BLACK ROCK 1, 2, AND 3 GEOTHERMAL POWER PROJECT - MAJOR AMENDMENT

Staff Assessment

02-AFC-2C

**BLACK ROCK 1, 2, 3, GEOTHERMAL PROJECT (02-AFC-2C)
STAFF ASSESSMENT to the AMENDMENT**

AIR QUALITY Figure 1
1998-2009 Historical Ozone^a and PM^{a, b} Air Quality Data^c
Niland-English Road, Westmorland-W 1st St., Brawley-220 Main St,
and El Centro 9th St. Stations, Imperial County

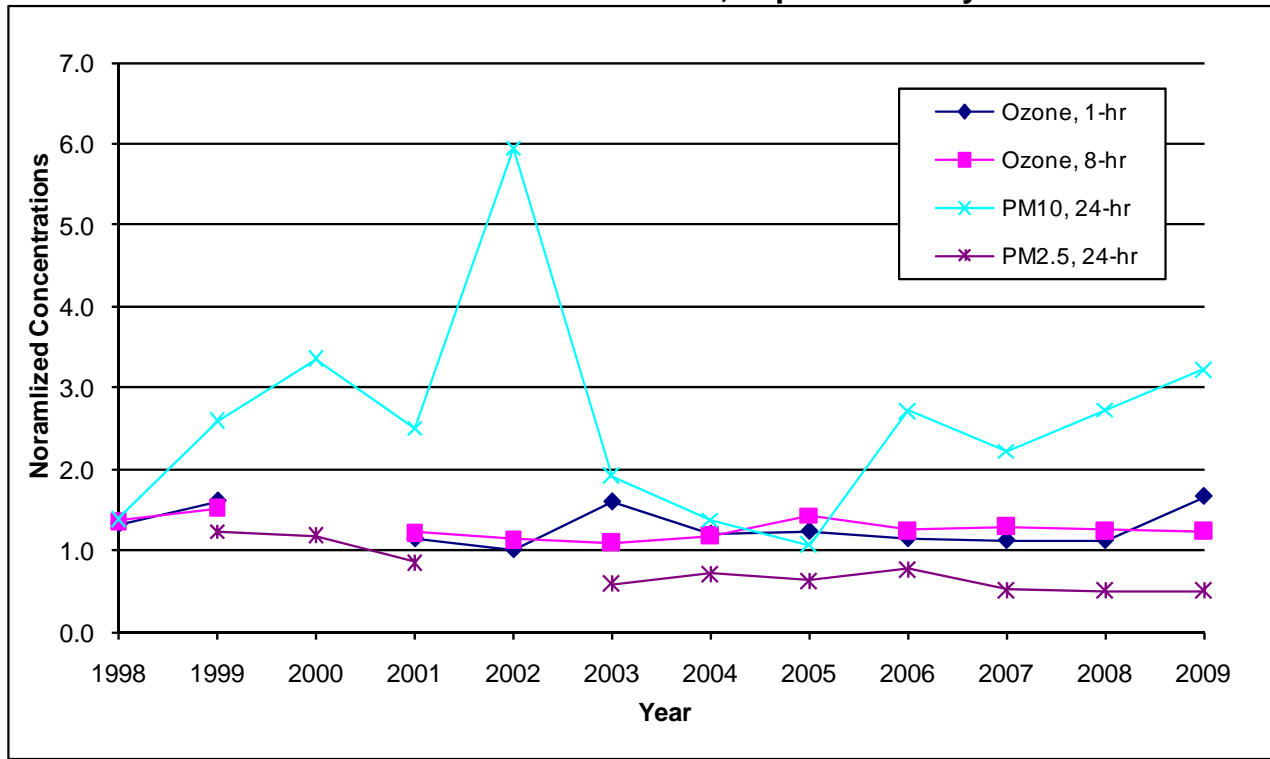
As **AIR QUALITY Table 4** and **AIR QUALITY Figure 1** indicate, the 1-hour and 8-hour ozone concentrations measured, with some annual variability, have been fairly constant over time. The collected air quality data (not shown) indicate that the ozone violations occurred primarily during the sunny and hot periods typical during May through September.

The area is nonattainment for the state and federal PM₁₀ standards. As shown in **AIR QUALITY Figure 1**, PM₁₀ concentrations were much higher than the state 24-hour PM₁₀ standard in the recent 12-year history. Imperial County in the site area is classified as attainment for the state and federal PM_{2.5} standards. This divergence between the PM₁₀ and PM_{2.5} attainment status indicates that a substantial fraction of the ambient particulate matter levels are most likely due to localized fugitive dust sources, such as vehicles travel on unpaved roads, agricultural operations, or wind-blown dust².
